Other Business – Response to enquiries from Ōrākei Local Board representative (Troy Churton)

This memo provides Auckland Airport's written response to questions raised by Ōrākei Local Board representative Mr Troy Churton in relation to Runway 23 approach procedures. The original questions and supporting material were circulated to committee members by Mr Churton on 2 June 2026 and are attached as an appendix.

Item tabled for 'other business' – Advice on 3 technical questions that have consequences for our communities

AUCKLAND
RNP X RWY 23L (AR)

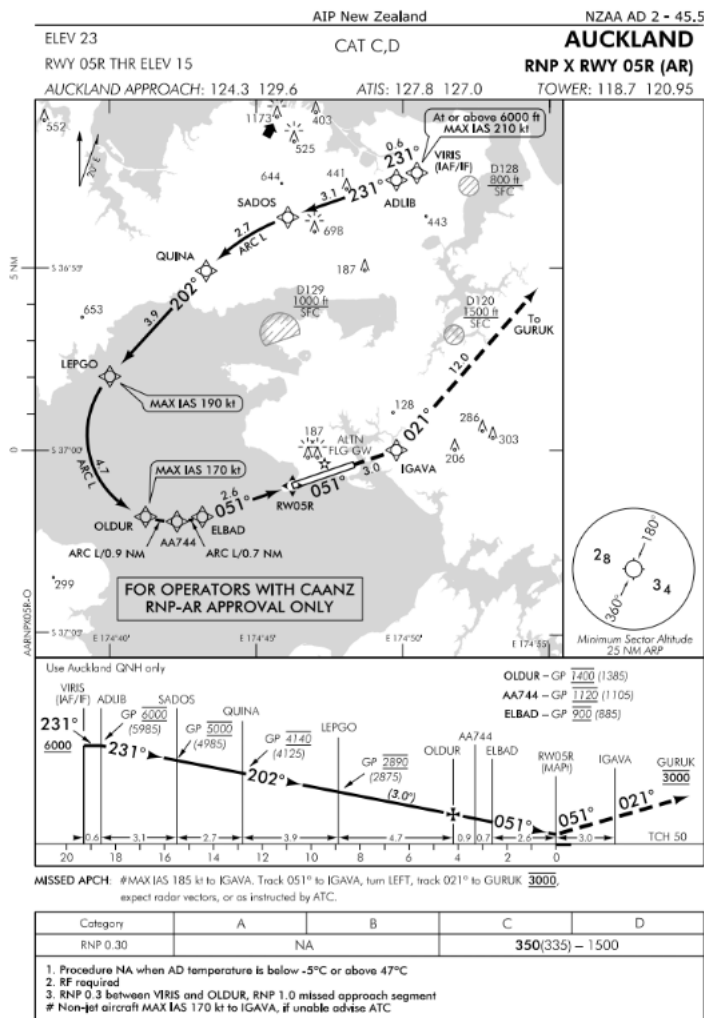
- Why are they allowed to intercept final on the Green x/ray approach to RW 23 at 1000' and 3nm? And inevitably this means using speed brakes - is that right?
- If the visual approach rules are to minimise noise, why is there an exception on an 'instrument approach'?

It seems the flightpath starts below 5000' somewhere over Mt Albert and descends linearly over residential areas until turning in for landing.
- Is it correct Airport/Airways no limit to the number of times this happens?

Although jets arriving from the north are currently not permitted to conduct visual approaches, the CAA has confirmed that, under the existing rules, Airways New Zealand may direct an aircraft on a visual approach to join final approach inside the 14 nautical mile minimum standard referred to in Civil Aviation Rule 93.61. No exemption is required for this.

Civil Aviation Rule 93.61 does not apply to instrument approaches. This reflects the fact that aircraft flying an instrument approach are not subject to the same centreline-joining procedures that apply to visual approaches. Rather, instrument approaches manage aircraft noise by design, as they use standardised, predictable flight paths, altitudes and descent profiles that support stable aircraft operation and minimise the need for short-notice manoeuvring or additional thrust and drag changes close to the runway. Aircraft on instrument approaches are typically already configured for landing, so the use of speed brakes is uncommon at this stage of flight. Where speed brakes are used, this is more likely to occur earlier in the descent in preparation for commencing an instrument approach, or during a visual approach where additional drag may be required over a shorter distance.

There is no regulatory limit on how often aircraft may operate using instrument approaches. Their use is determined by operational and safety requirements, including weather conditions, traffic levels and how aircraft are sequenced through the airspace.

AUCKLAND
RNP X RWY 05R (AR)

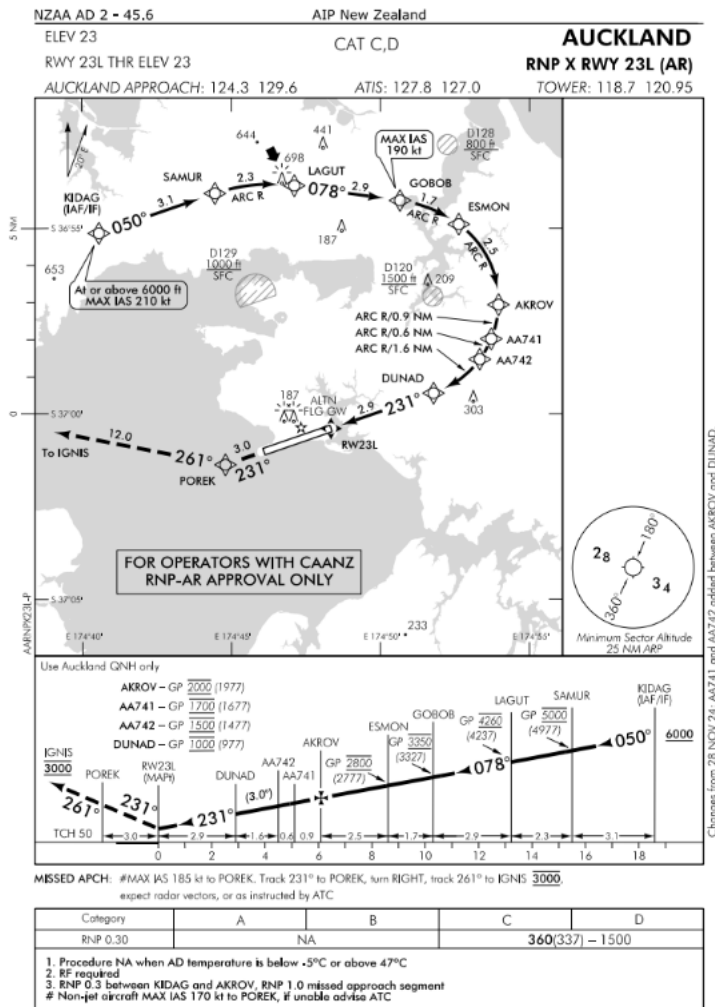
1. the instrument approach charts. (I note too that the approach to RW05 crosses Hillsborough at 3000'), and
2. an AI description of the approach
